From: drainage <drainage@midsussex.gov.uk>
Sent: 30 May 2025 17:05:51 UTC+01:00
To: "Anna Tidey" <anna.tidey@midsussex.gov.uk>
Cc: "drainage" <drainage@midsussex.gov.uk>
Subject: 2025.05.30 Re: DM/25/0579 - Hammonds Mill Farm-Class Q Prior Approval Application
Attachments: DM250579 300525.docx

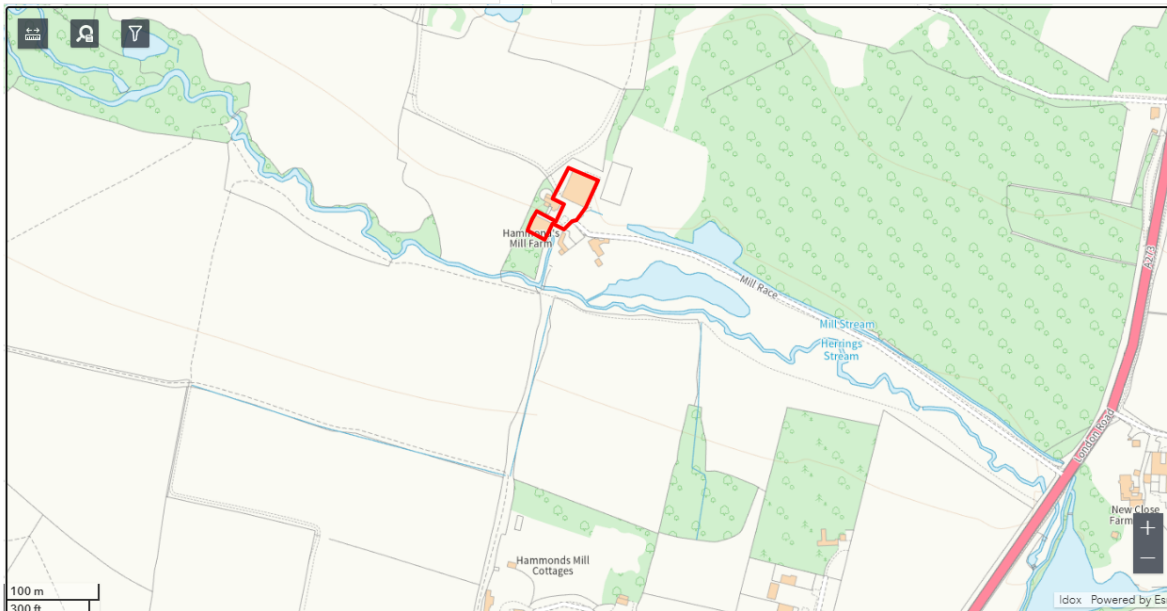
Also location plan (application boundary) provided by the applicant (P_0211_00_Rev A_Hammonds Mill_Class Q Application_Location Plan_master) is different to what is on the MSDC website. For clarity I have based my comments on the location plan (P_0211_00_Rev A_Hammonds Mill_Class Q Application_Location Plan_master)
